Montgomery

UNfair To Neighbours

Chapter 2 Residential Land Use

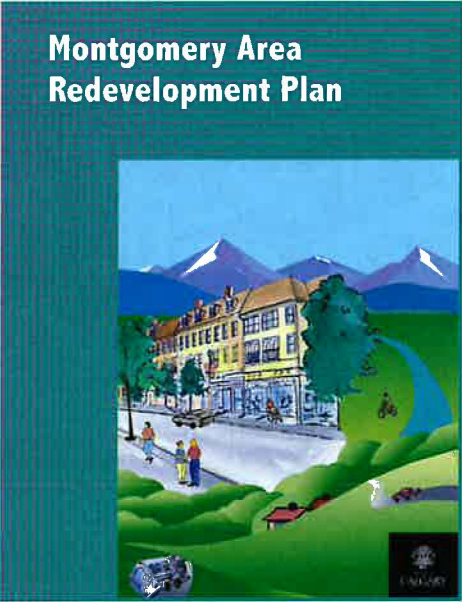
Doesn't follow Community Guidelines
